PROPOSED NORTHCONNEX M1 / M2 TUNNEL PROJECT - Application Number - SSI 13_6136
We object to many aspects of this project

SUMMARY OF CONCERNS IN RELATION TO THE PROPOSED NORTHCONNEX TUNNEL

SECTION A: THE CONNECTIVITY OF NORTHCONNEX SOUTHERN VENTILATION FACILITY AT THE SOUTHERN INTERCHANGE, THE SOUTHBOUND TUNNEL IN PARTICULAR

Figure 5-17 Motorway operations complex

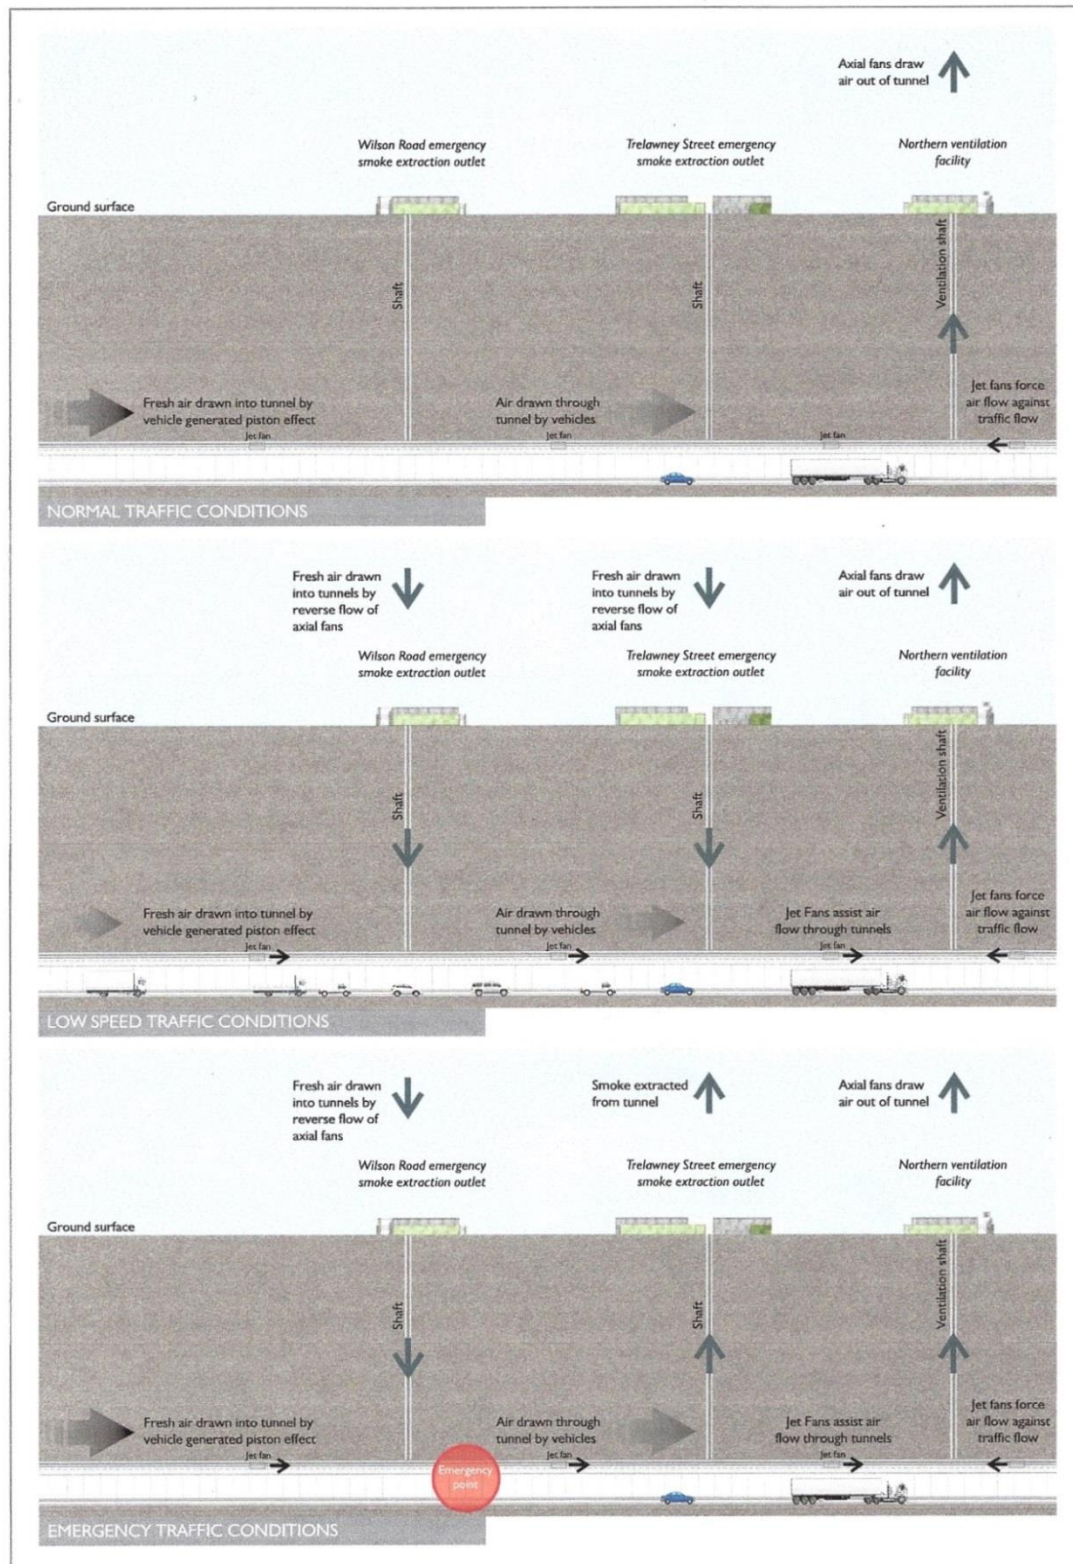
EIS Page 111, *Figure 5-17 Motorway operations complex*

Page 8 below there is no indication of how the ventilation facility will be connected to either the northbound or southbound tunnel, nor is there any indication of how the southbound exit portal onto Pennant Hills Road or the south-west exit portal onto the M2 will be connected.

In each of the above figures for Wilson Road, Trelawney Street, and Northern Ventilation facility, the shafts, emergency smoke extraction buildings, and ventilation facility make a substantial footprint in the construction area; however for the Southern Interchange the ventilation facility is an insignificant part of the construction area. How can this be? The difference in scale does not explain the difference.

MOTORWAY OPERATIONS COMPLEX - SOUTHERN VENTILATION FACILITY - SECTIONS
M1-M2-5000-DR-JD-0525

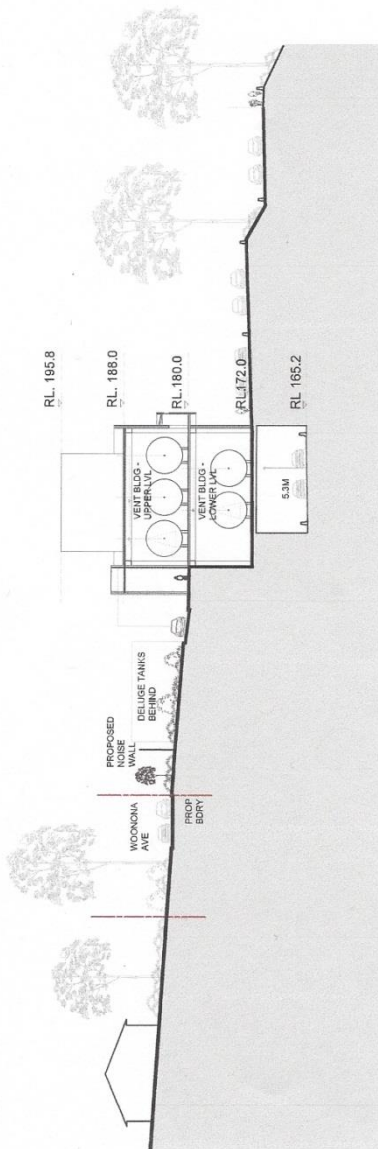
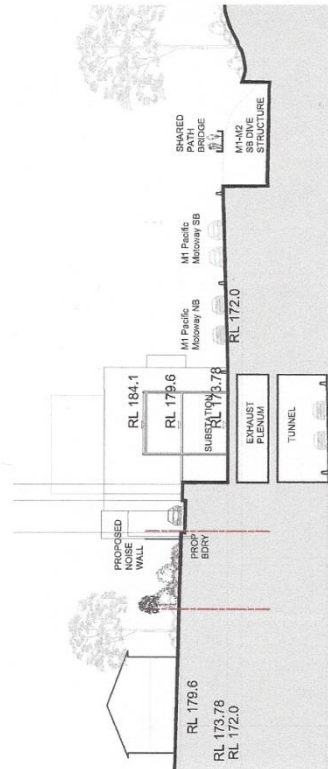
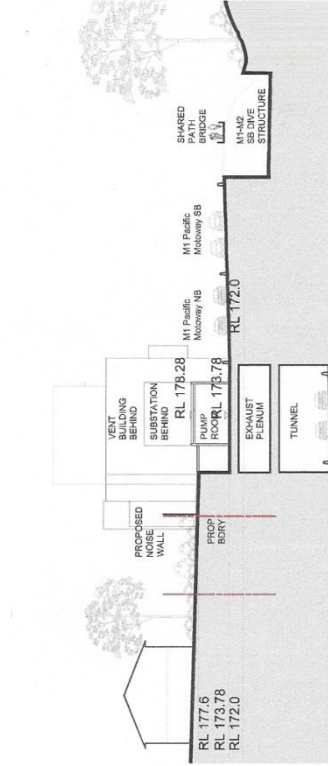
5. *EIS Volume 4, Technical working papers - Urban Design, 6.0 Operational Ancillary Facilities*
EIS Page 99 there is the diagram "Motorway Operations Complex – Southern Ventilation Facility – sections. *Page 10 below* The diagram has the cryptic label "Connection to tunnel TBC". What does TBC stand for? To be considered? Why is tunnel singular? Which tunnel is the diagram referring to northbound or southbound? There is no diagram showing any connection from the Southern Interchange ventilation facility to either the northbound or the southbound tunnel in any way AND YET

Why are there no comparable diagrams for the Southern Interchange and the Southern Ventilation facility?

M1-M2-5000-DR-UD-0550
NORTHERN VENTILATION FACILITY - CROSS SECTIONS

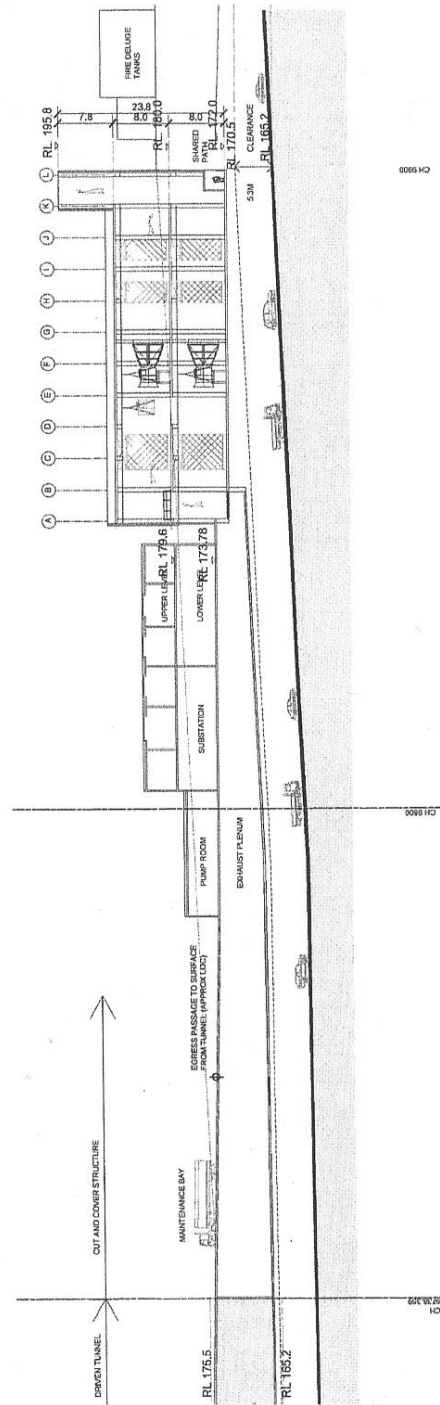
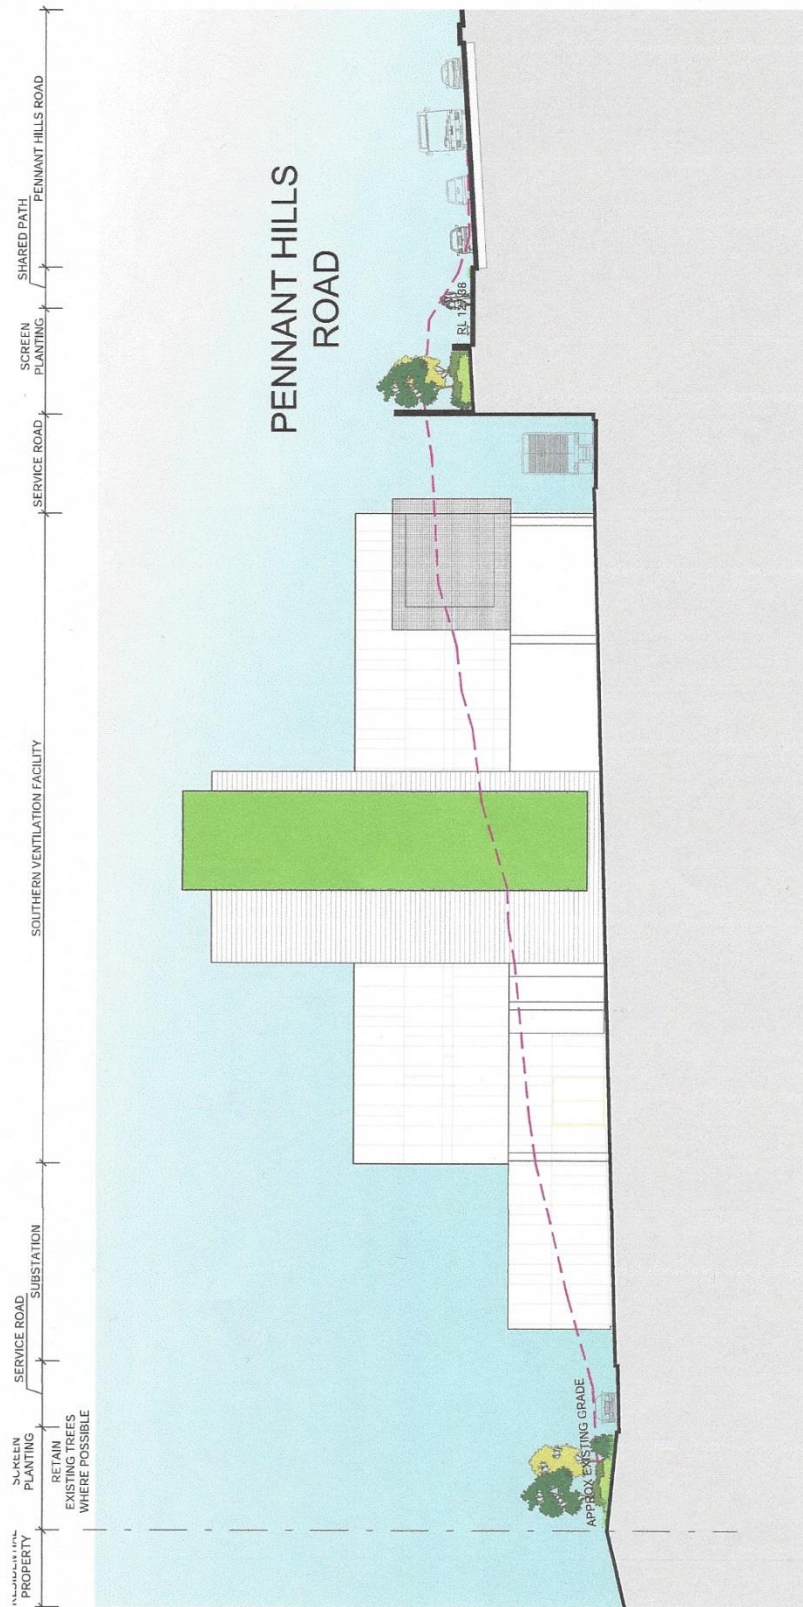
EIS page 135 *Page 11 below* there is a very explicit diagram showing the *Northern Ventilation Facility – cross section*.

EIS page 134 *Page 12 below* there is a very explicit diagram showing the *Northern Ventilation Facility – long section*.
